Groundwater Application Review Summary Form

Application # G- 18851

GW Reviewer Michael Thoma Date Review Completed: 06/16/2020

PUBLIC INTEREST REVIEW FOR GROUNDWATER APPLICATIONS

Hunt (2003) transient stream depletion model

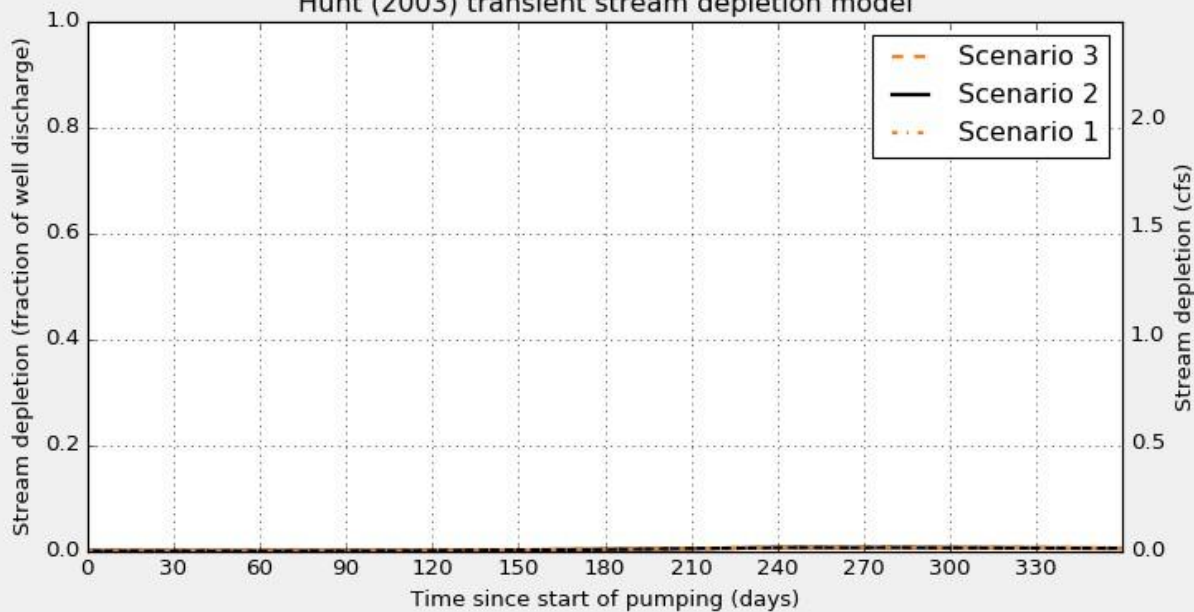
Basis for impact evaluation: Stream-depletion was estimated for each well to Snake Creek (which has the lower WAB flows) using the Hunt (2003) stream-depletion model with parameter values informed by Gannett et al. (2012) and using methods previously used by the Department for estimating stream-depletion in the Klamath Basin. The main control on stream-depletion for this application is the distance to the nearest, hydraulically-connected stream reach, which is based on assumed static water levels and on proposed construction. Stream-depletion estimates are assumed to be different if the well is not constructed as proposed.

C6. **SW / GW Remarks and Conditions:** The applicant's proposed POAs would be producing from an aquifer that has been found to be hydraulically connected to surface water – specifically Fivemile Creek and Snake Creek – at distances of over 3 miles. Stream-depletion was estimated using standard practices of the Department and the proposed rate and level of impact does not reach the level where PSI is assumed.
